**Errata for the 4th Printing of  
"Understanding Digital Signal Processing, 2/E",  
by Richard Lyons**

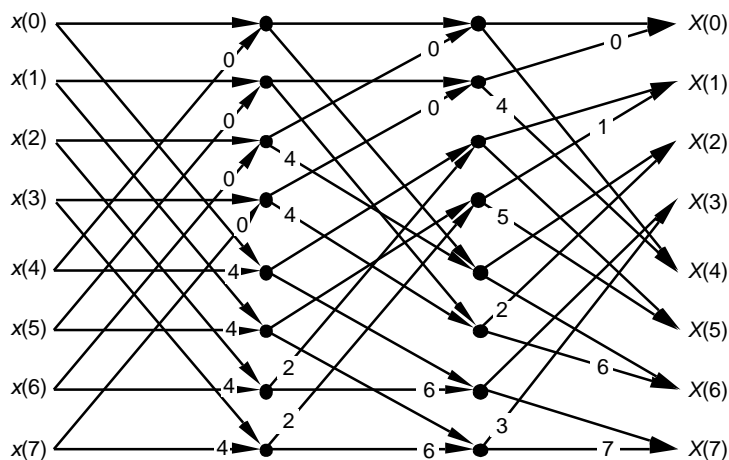
**Page 143:** In Figure 4-10, in the middle stage there is the number 4 on the 1st and 2nd (counting down from the top) southeast-pointing arrows. Those 4s should not be there. The 4s should be on the 3rd and 4th southeast-pointing arrows of the middle stage as shown below.

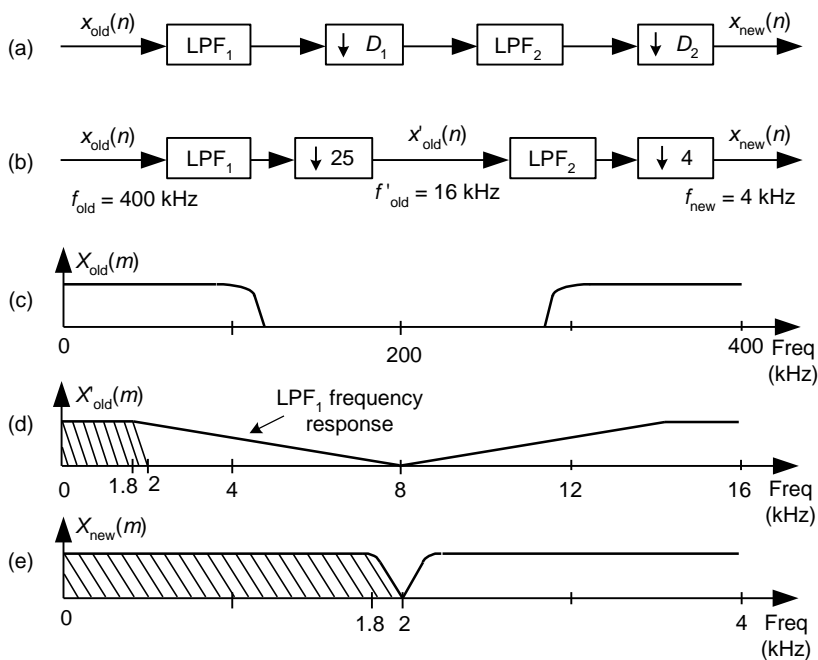
-----  
**Page 384:** The "shading" in two places at the bottom in Figure 10-3 doesn't show up in the figure.

The shading in Figure 10-3 should look like the following:

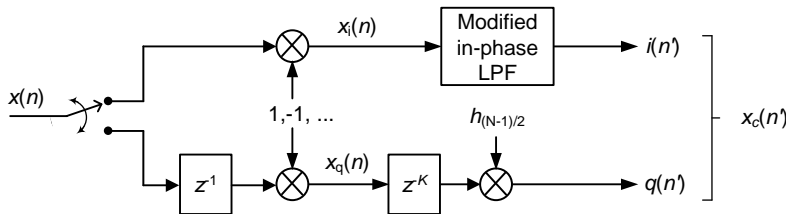
**Page 478:** in the fifth line down, delete the text:

"...followed by another K delay..."

In Figure 13-6(c) the final  $z^{-K}$  delay block should be deleted making that figure look as follows:

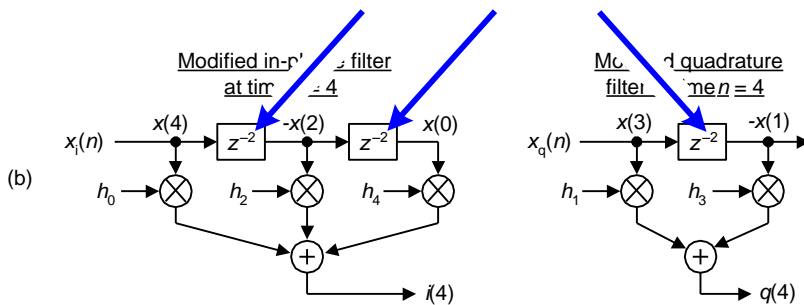
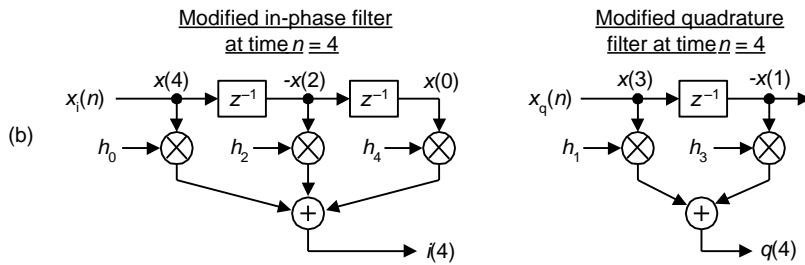
**Page 479:** In Figure 13-6(b) the superscripted "-2" characters shown by the large arrows below:

Should be changed from "-2" to "-1" making Figure 13-6(b) become:

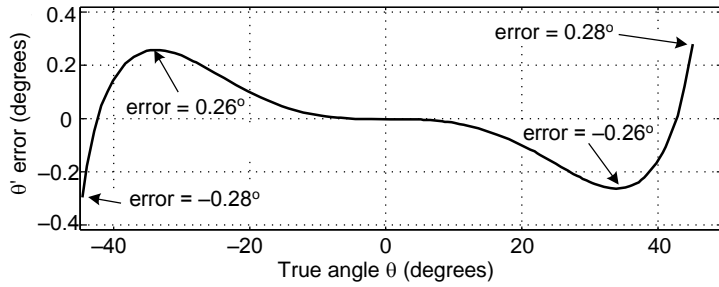
**Page 548:** 4th line below Eq. (13-107), change the text:

"... 0.26° using ..."

to

"... 0.28° using ...".

For preciseness, you might note on Figure 13-59 that the error is  $-0.28^\circ$  at True  $\theta = -45^\circ$ , and the error is  $+0.28^\circ$  at True  $\theta = +45^\circ$ , as shown in the following figure.

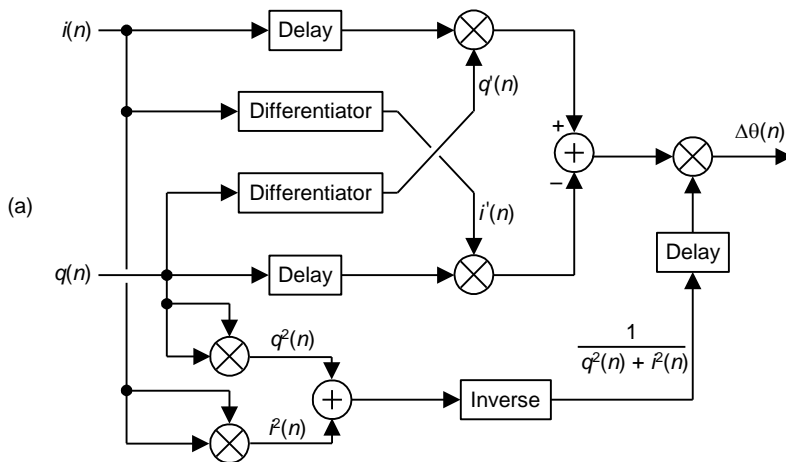
**Page 551:** In Figure 13-61(a) there needs to be a Delay element inserted just after the "Inverse" operation as shown below. The length of that (missing) Delay element should be the same length as the Delays in the I and Q input paths.

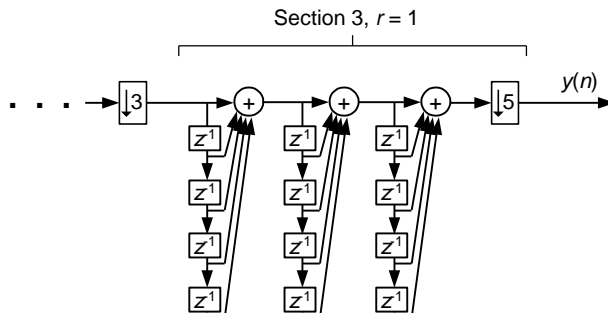
**Page 560:** In Figure 13-70(b), on the right side in the "Section 3, r = 1" part of the figure, there should be three stages of delay lines instead of only two stages as shown in the figure. That "Section 3, r = 1" part of the figure should look like the following:
